The Town of Hilton Head Island
Design Review Board Regular Meeting
Tuesday, October 8, 2019 – 1:15 p.m.
Benjamin M. Racusin Council Chambers
AGENDA

Town of Hilton Head Island
Design Review Board

8 Office Way Restaurant Project Narrative:

**PROPOSED SITE PLAN
 A PROPOSED RESTAURANT @
 #8 OFFICE WAY
 HILTON HEAD ISLAND, SC**

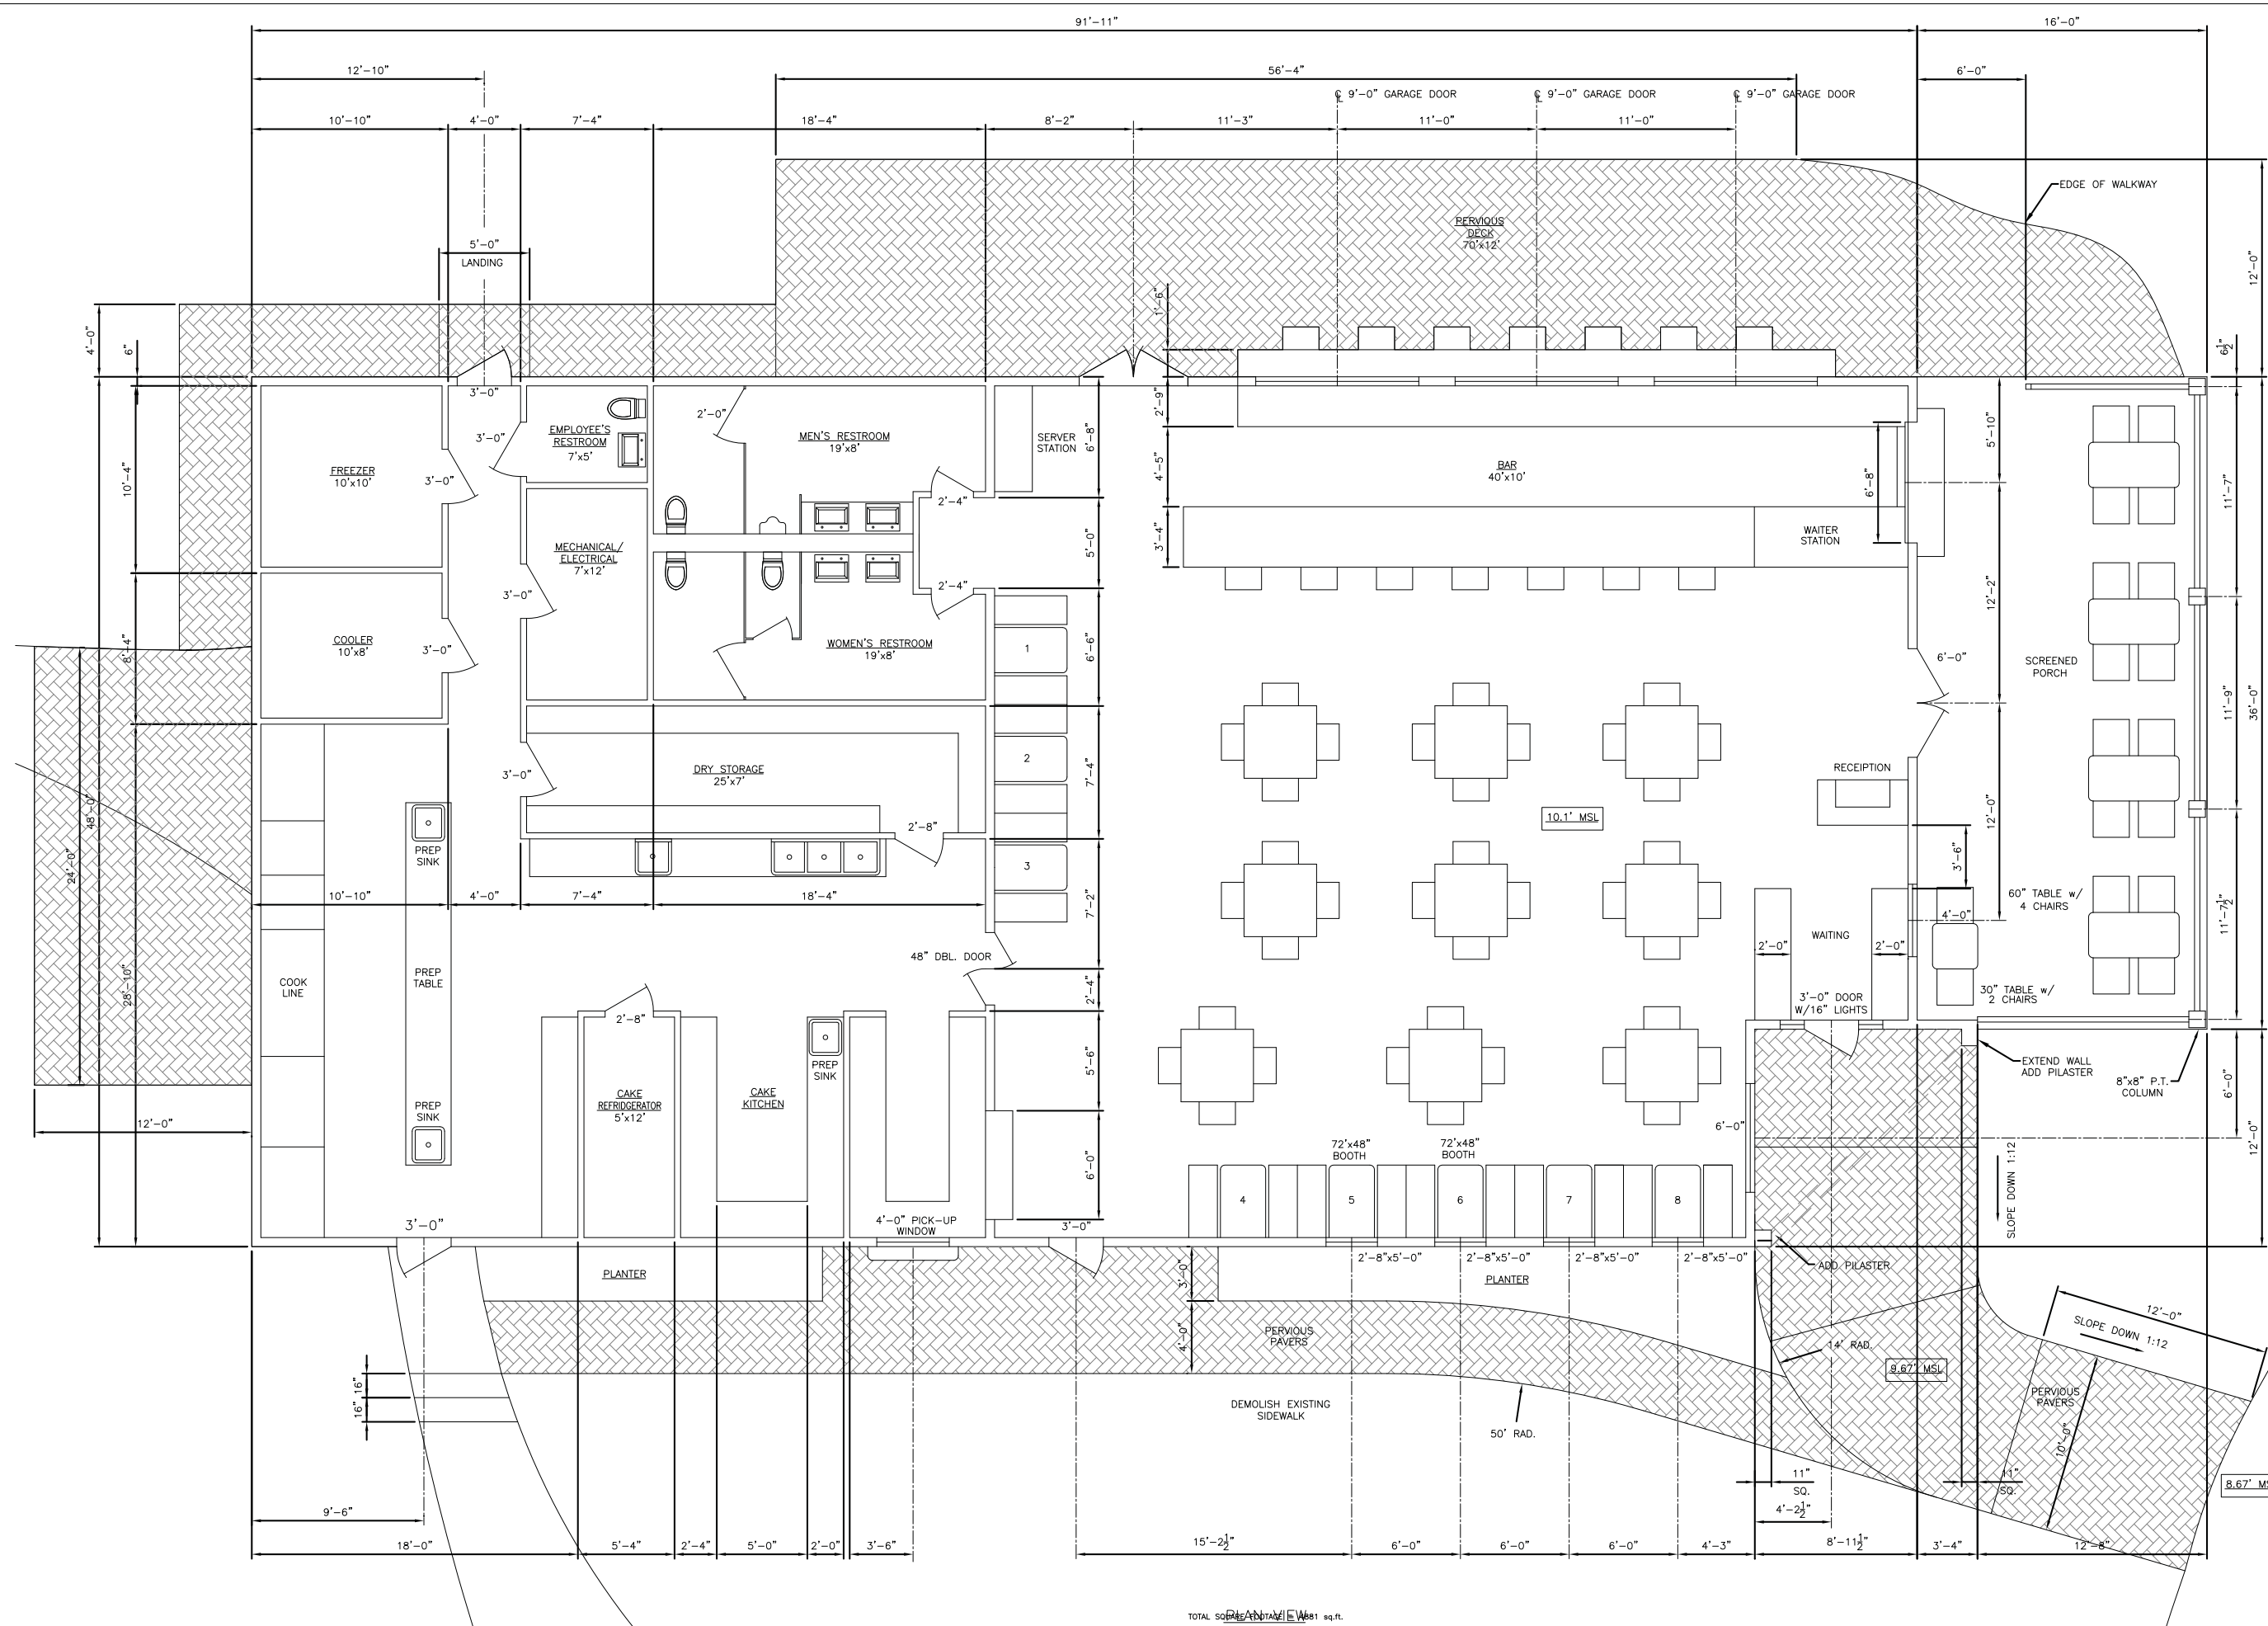
DESIGN GUIDE/LMO CRITERIA	Complies Yes	No	Not Applicable	Comments or Conditions
An effort has been made to preserve existing trees and under story plants	<input type="checkbox"/>	<input checked="" type="checkbox"/>	<input type="checkbox"/>	Consider elimination of the patio connection to the front porch to preserve the adj. pine.

1. Eliminate the patio behind the building. There is no direct connection to the back patio and it is unscreened.
2. Effort should be made to coordinate the dumpster enclosure with the building and to provide additional screening of the dumpster enclosure with landscape material.

SOUTH ELEVATION

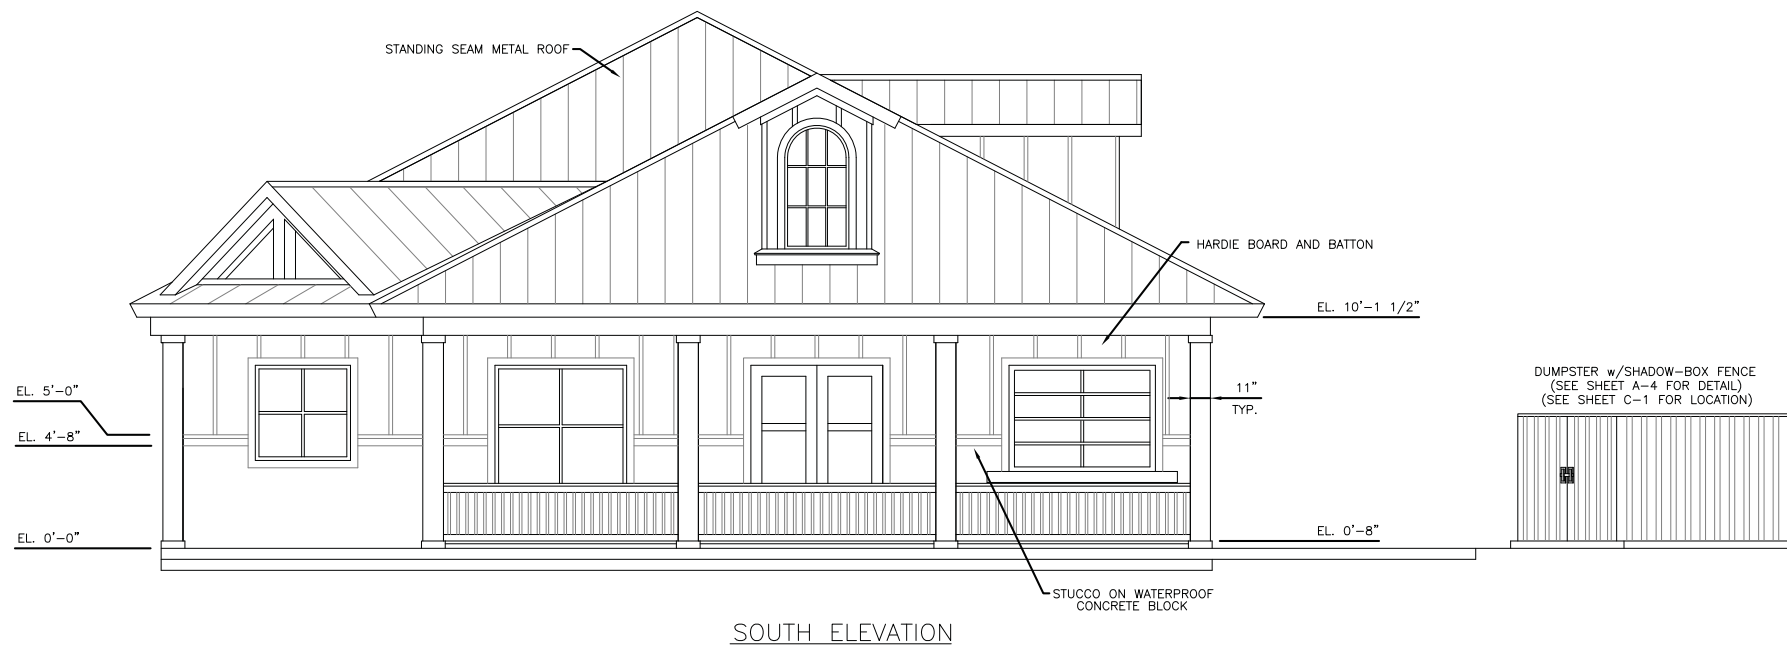
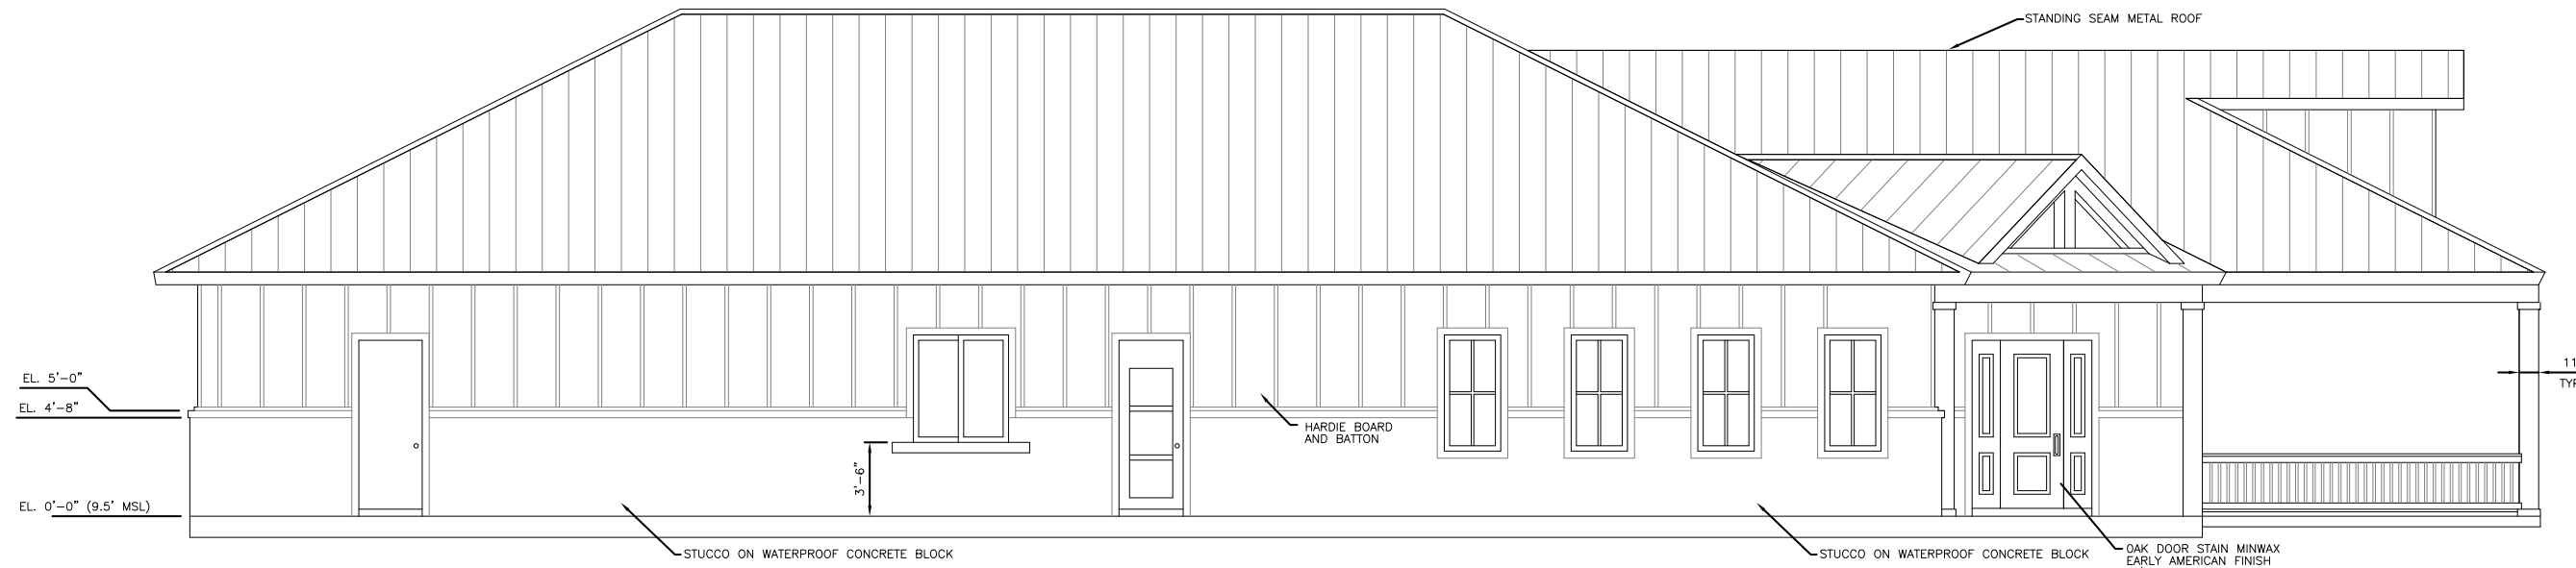
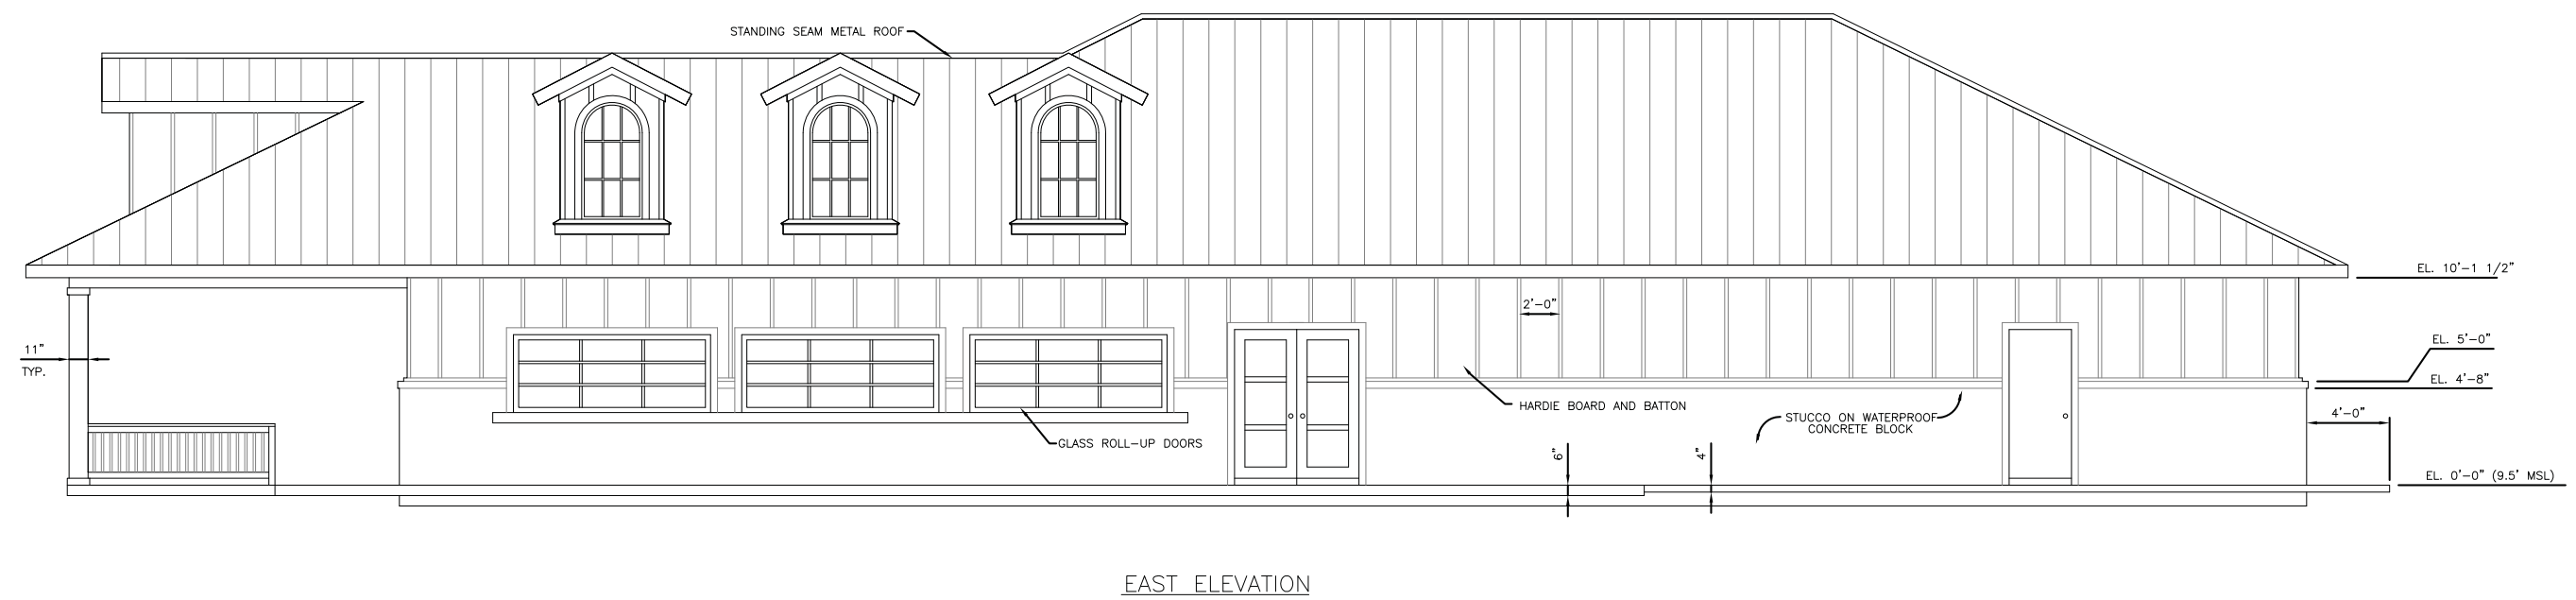
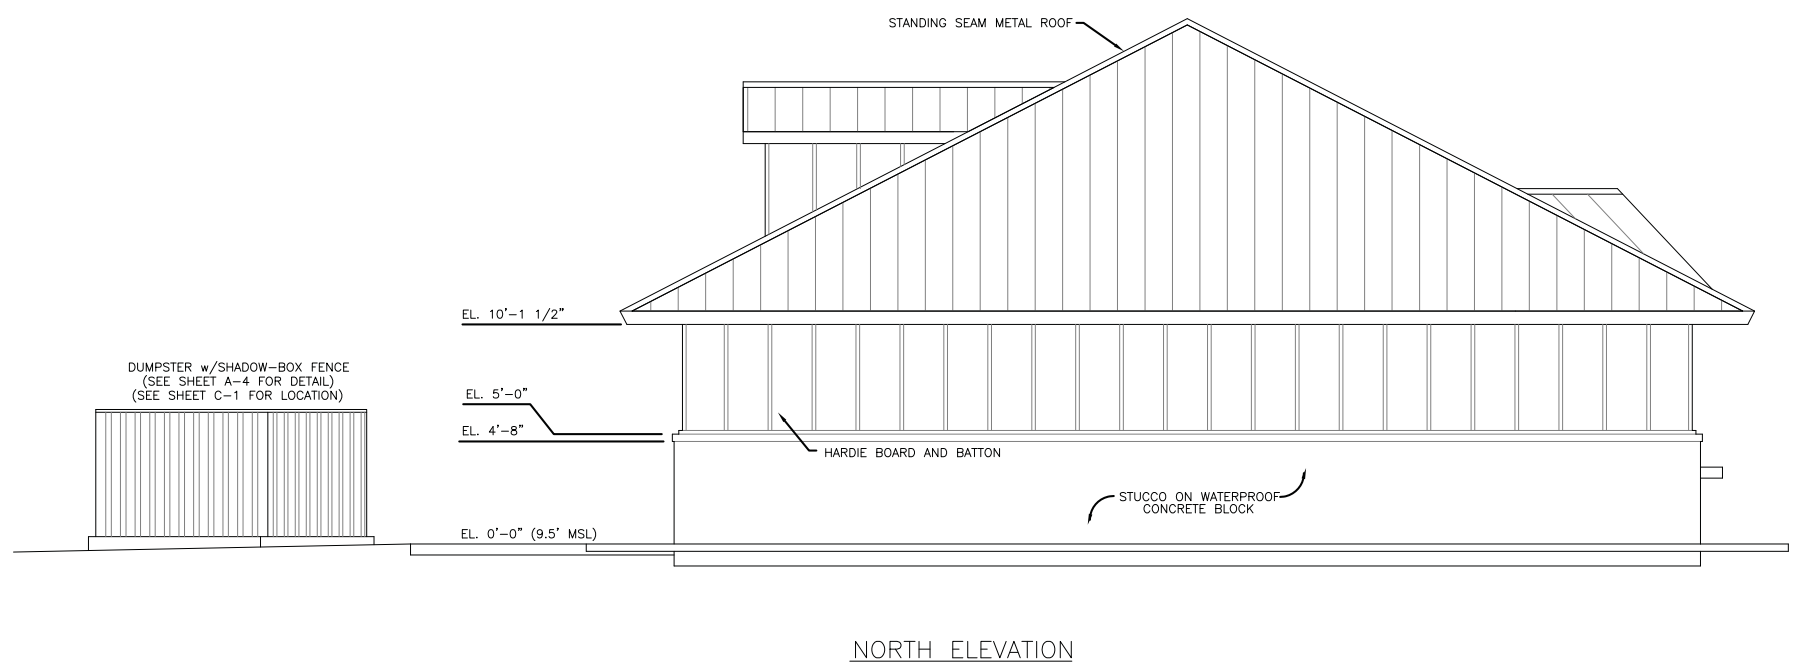
DESIGN GUIDE/LMO CRITERIA	Complies Yes	No	Not Applicable	Comments or Conditions
Utilizes natural materials and colors	<input type="checkbox"/>	<input checked="" type="checkbox"/>	<input type="checkbox"/>	The SW "Fired Brick" is not in keeping with the Design Guide as a color for the main mass of a building.
Utilities and equipment are concealed from view	<input type="checkbox"/>	<input checked="" type="checkbox"/>	<input type="checkbox"/>	Provide utility locations and screening if necessary at final review.
Decorative lighting is limited and low wattage and adds to the visual character	<input type="checkbox"/>	<input checked="" type="checkbox"/>	<input type="checkbox"/>	Provide a lighting plan for review at final.

Paint Scheme

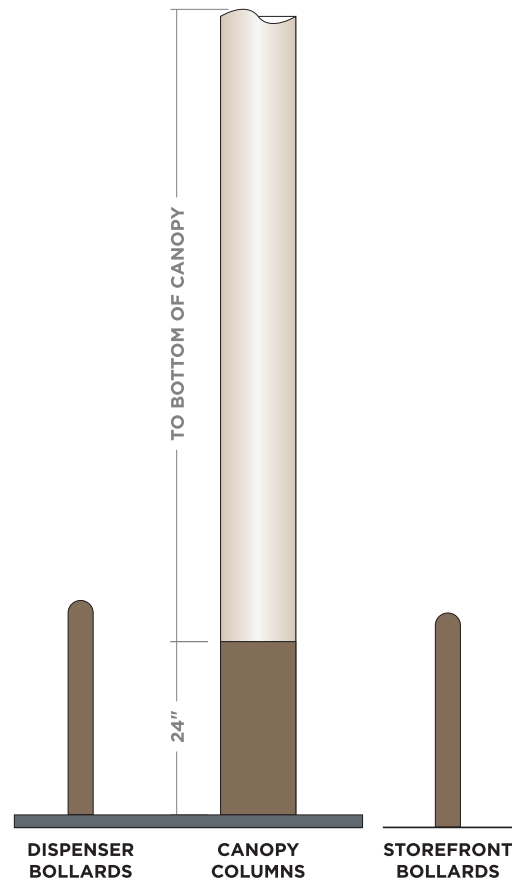
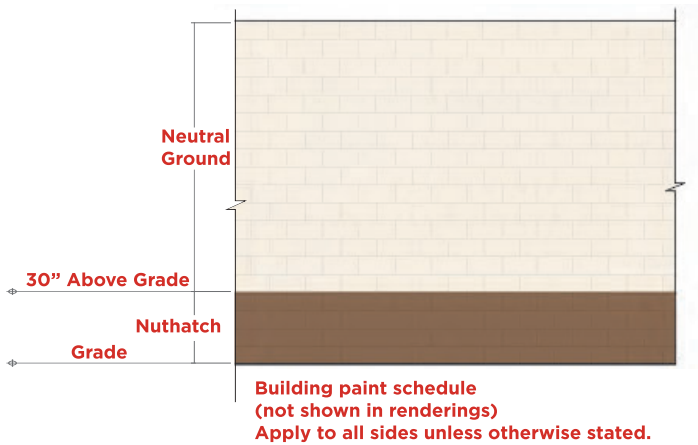
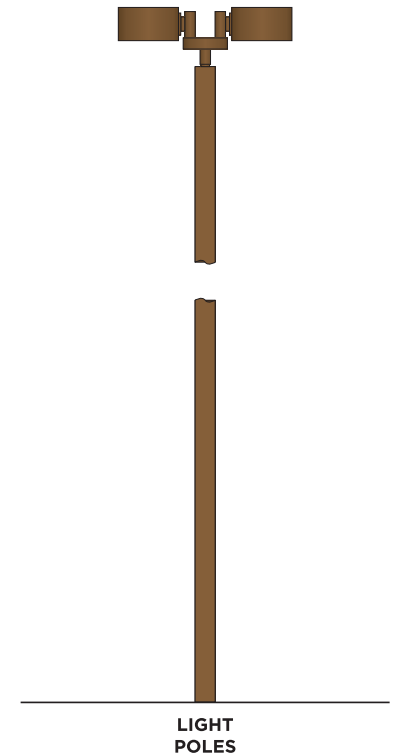
1. The proposed sign must include the street address at the top of the sign in 4" letters.
2. The dispensers (pumps) shall be beige. Cut sheet to be approved by Staff.
3. ~~The dispenser cabinet shall be painted Nuthatch.~~
4. Specify on the drawings "column color to match existing building color".
5. Trash cans should be bronze and not include commercial copy.
6. ~~Specify, on the drawings, that the monument sign, changeable copy background (currently SW "In the Navy") shall be dark brown to be approved by Staff.~~
8. Any additional Signage (i.e. Air-Vac) shall have a brown background with beige lettering.
9. ~~Mark through the "Building Paint Schedule" detail on Circle K Paint Specifications sheet as not included in this project.~~

8.—It is Staff’s understanding that the building will not be painted. The “Building Paint Schedule” must be marked through to delete it from the application.
